# AMENDMENT OF THE MARKET ANCILLARY SERVICE SPECIFICATION – DER AND GENERAL CONSULTATION

FINAL REPORT AND DETERMINATION

Published: **22 December 2021**

Fig. 1 - FCAS response from a 5kW device, with a superimposed oscillation of 1.3Hz. This illustrates that if the oscillation period is not a harmonic of the 1Hz sampling rate, then even 1-s sampling may provide information regarding the magnitude of any oscillation present.

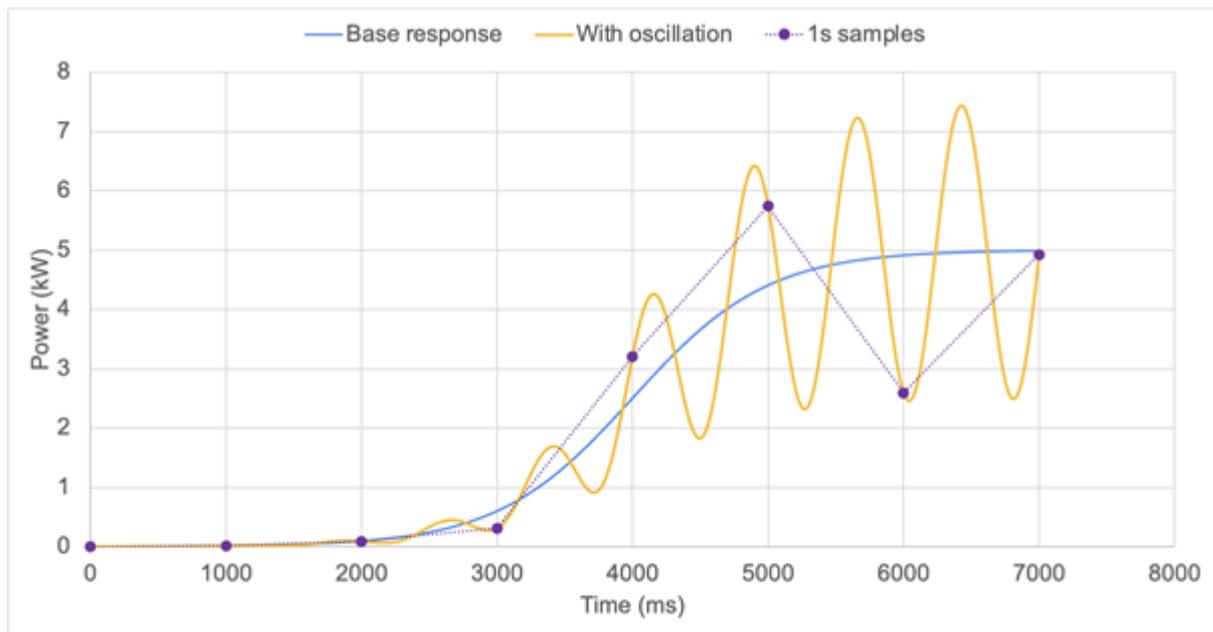
Fig. 1 shows 1-s sampling of an oscillatory response profile with an oscillation period of 0.769 s (1.3 Hz). In this case, the oscillation frequency is not a harmonic of the sampling frequency. The result is that successive samples do not always appear at the same point in each cycle.

1-s sampling is able to provide insight into the magnitude of deviation from the base case, under these conditions. This would even work for higher frequency oscillations, provided the frequency of oscillation was not a harmonic of 1Hz.

Had UoM considered the 1-s sample rate case in their study, they may have arrived at a different method for oscillation detection, and could have revealed some success in detecting oscillations even with 1-s sampling.

**Figure 2 Example of assessment windows based on 50 ms and 100 ms sampling rates from 25 May 2021 event**

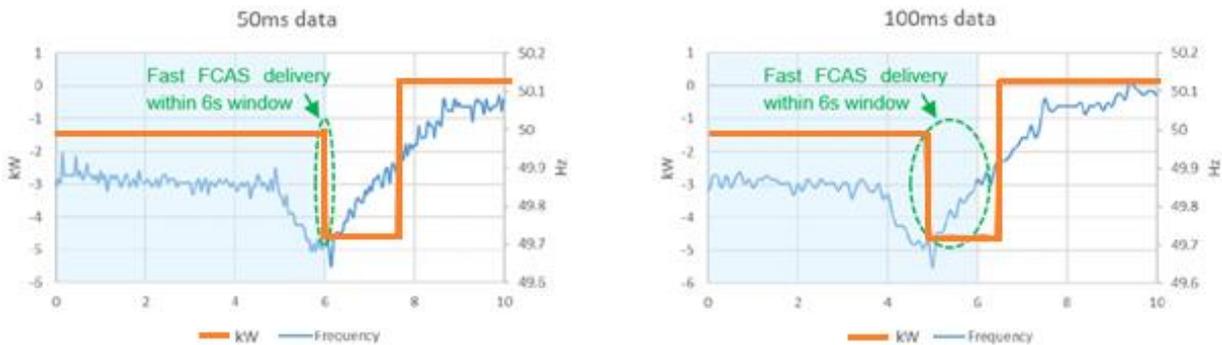
In Figure 2, the area that indicates the assessed energy delivered (indicated by dotted green circle) as Fast FCAS within the delivery window (blue window) and the associated error with a 100 ms sampling rate has been calculated as follows:

- Using 50 ms data, the area is determined as close to 0 kW (s) (-0.0038 kW (s)) as a step change in active power is only observed at the very end of the first 6 s when the FDT is identified using 50 ms data.
- Using 100 ms data, the area is determined as -3.509 kW (s) as a change in active power occurs within the first 6 s when the FDT is identified using 100 ms data.
- The verification error in comparing response using 100 ms vs response using 50 ms is then determined as 922% ( $= (-3.509 - -0.0038) / -0.0038$ ).

**Figure 3 Example of assessment windows based on 50 ms and 200 ms sampling rates from 25 August 2021 event**

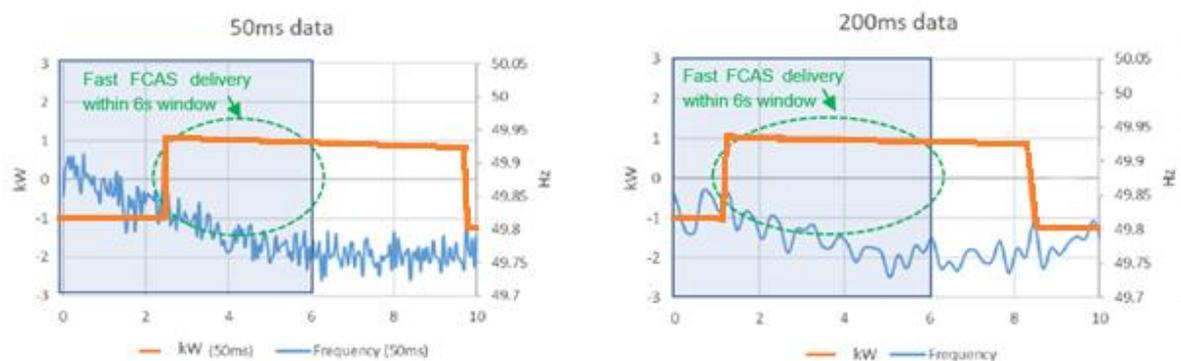
In Figure 3, the area that indicates the assessed energy delivered (indicated by dotted green circle) as Fast FCAS within the delivery window (blue window) and the associated error with a slower sampling rate has been calculated as follows:

**Figure 4 Frequency observed during 25 May 2021 event**

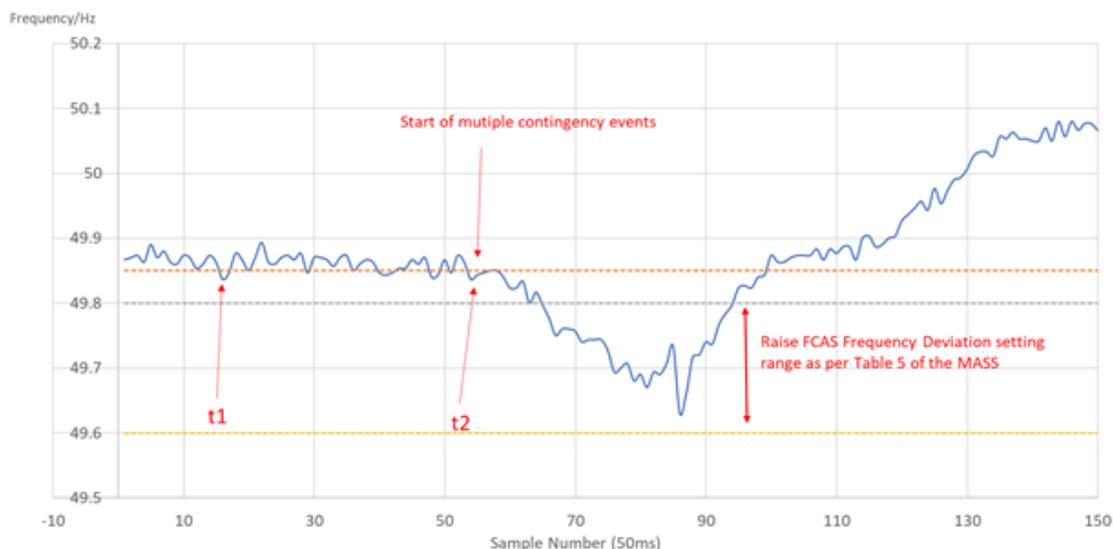
The CTI methodology to identify the start point of the assessment window is demonstrated in Figure 4. The frequency trace for the 25 May 2021 event is considered in this example, as it clearly shows why the CTI is necessary to identify the relevant assessment window under some conditions, as the start of the six-second assessment window should not be before the start of the contingency event being analysed. This is shown in Appendix A of the MASS.

To identify the commencement of the contingency event for the purposes of FCAS assessment, it is necessary to apply the definition of ‘Contingency Event Time’ in the Glossary in section 1.2.1 of the MASS. In this example, paragraph (b) of the definition is relevant, as it applies when there is a series of step changes in frequency. The commencement of the contingency event will be at the start of the greatest rate of change of frequency, as measured by AEMO.

In this example, the frequency is already close to the lower limit of the NOFB before the start of the multiple contingency events. Without applying the CTI, the FCAS assessment would start at t1, which is not consistent with paragraph (b) of the definition of ‘Contingency Event Time’. The FCAS assessment should start from t2 and the CTI is applied to identify the start point of the six-second assessment window to be closer to t2 than t1.

**Figure 5 Detection of oscillatory response with data captured at 1 s intervals**

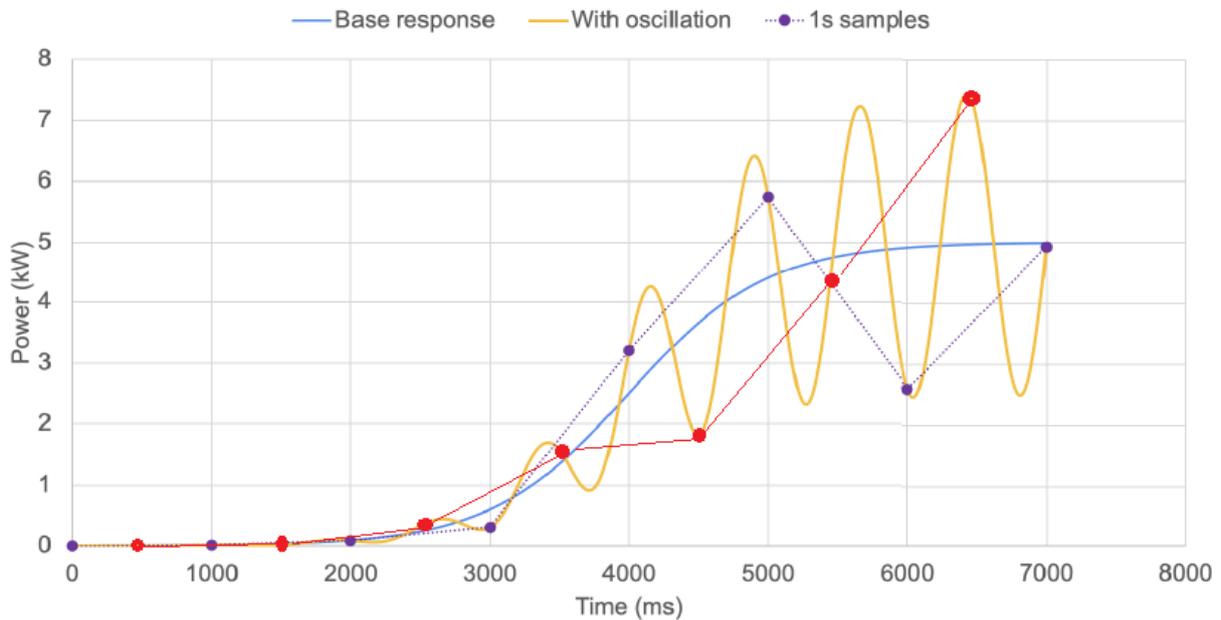
Evergen considered a response profile with an oscillatory period of 0.769 s (1.3 Hz) to suggest that a 1 s measurement time resolution could detect an oscillation in many circumstances. The case study using a response profile with a period of 1.3 Hz assumes that the measurements are sampled at the right instance to capture the oscillatory behaviour. If the samples were offset by approximately 500 ms, the oscillatory behaviour would not be detected as shown in Figure 5. AEMO has superimposed the red line to demonstrate the different outcome if the samples were taken approximately 500 ms later. Hence, AEMO disagrees with Evergen's contention that 'there is the possibility that 1 s sampling could detect an oscillation in many circumstances' and that 1 s sampling is therefore low risk.
